# UNITED STATES PATENT AND TRADEMARK OFFICE

APPLICATION NO.	FILING DATE	FIRST NAMED INVENTOR	ATTORNEY DOCKET NO.	CONFIRMATION NO.
10/028,909	12/28/2001	Dietmar Przytulla	2511-099	2675
7590 10/20/2004				
HENRY M. FEIEREISEN 350 FIFTH AVENUE, SUITE 4714 NEW YORK, NY 10118				
			EXAMINER DEL SOLE, JOSEPH S	
			ART UNIT 1722	PAPER NUMBER
DATE MAILED: 10/20/2004

<b>Office Action Summary</b>	<b>Application No.</b> 10/028,909	<b>Applicant(s)</b> PRZYTULLA ET AL.	
	<b>Examiner</b> Joseph S. Del Sole	<b>Art Unit</b> 1722

## **DETAILED ACTION**

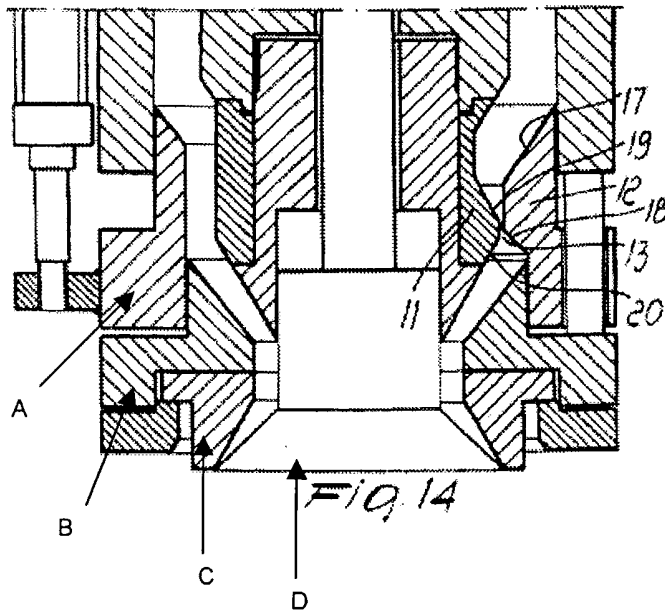
11. Claims 13-15, 17, 18, 20 and 22-23 are rejected under 35 U.S.C. 102(b) as being anticipated by Tietto (EP 0 478 957 A1).

Tietto teaches a parison extrusion device having an extrusion end provided with an adjustable nozzle gap (Fig 14):

formed between cooperating first, second and third control elements on a first side of the nozzle gap (Figure 14, Examiner added A, B and C above) and an adjustable mandrel (Fig 14, D) on a second, opposite side of the nozzle gap (Fig 14); the first, second and third control elements are adjacent to one another with the first control element being farthest from a nozzle exit from which a parison is extruded, the third control element is closest to the nozzle exit and the second control element is positioned between the first and third control elements (Fig 14); the second, and third control elements (Fig 14, B and D) are independently movable (see Figures 8 and 14) relative to the first control element (Fig 14, A); the mandrel is mounted on an axially adjustable mandrel support (Fig 14); the mandrel has a truncated cone shape (Fig 14); the gap-delimiting surfaces of the mandrel and the second control element are smooth while gap-delimiting surfaces of the first and third control elements are contoured (Fig

14); and a bottom-most inner edge of the third control element is positioned no lower than a bottom-most outer edge of the mandrel (Fig 14).
